URGENT – Field Safety Notice (FSN)

Product: Tenor without scale
Serial Numbers: All devices manufactured since Tenor was placed on the market in 2004, not equipped with scale
Issue Date: 2014-04-08
Type of action: Safety Notice / Change the spreader bar without scale to the spreader bar with scale.
Ref: FSN/POZ/001-2014

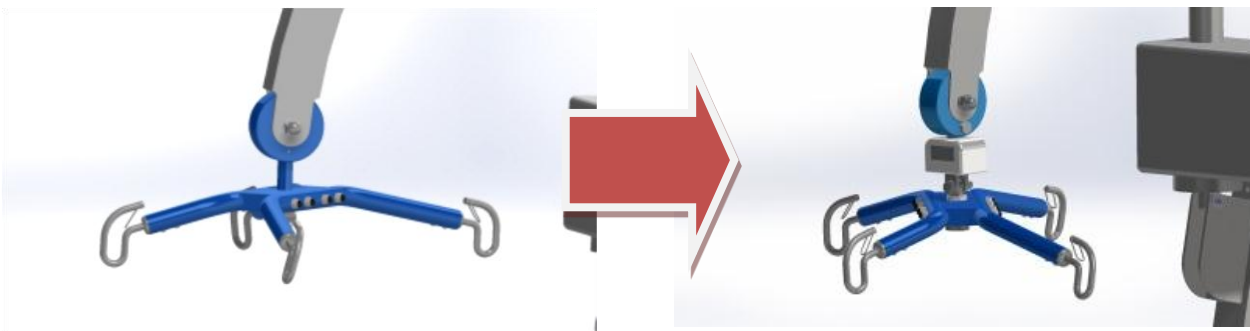
As part of our continuous monitoring of the complaints, we have found a remote risk concerning the breakage of the spreader bar bolt connection part # TEN.018.

During use, the bolt (part# TEN.018) when used in a Tenor **without** scale is subjected to mechanical forces, which may lead to breakage. This is due to the design of the connection between spreader bar and lifting arm jig, which in long term use can cause metal fatigue in this part and the formation of micro-cracks in the thread of the bolt.

The assembly replacement shown below is **only** related to the Tenor devices **without scale**. The Tenor devices with scale have a different design that avoids sideward stress on the scale unit and spreader bar assembly, and is not involved in this field action.

Our records indicate that your facility has purchased one or more of the ArjoHuntleigh Tenors involved in this field action. For these Tenors, ArjoHuntleigh offers you free of charge a new spreader bar including scale to replace the spreader bar currently on your device.

1. Please make sure that a copy of this field safety notice (FSN) is placed with the instructions for use for the products listed in this notice.
2. It is very important that the form in Appendix A of this FSN (see next page) is completed and returned to the ArjoHuntleigh Sales and Service office (SSU) or ArjoHuntleigh representative as soon as is reasonably possible.
3. The ArjoHuntleigh Sales and Service office shall arrange for an ArjoHuntleigh service technician to visit your facility to carry out these updates - retrieve and destroy the old spreader bar and replace it with the new one with scale.
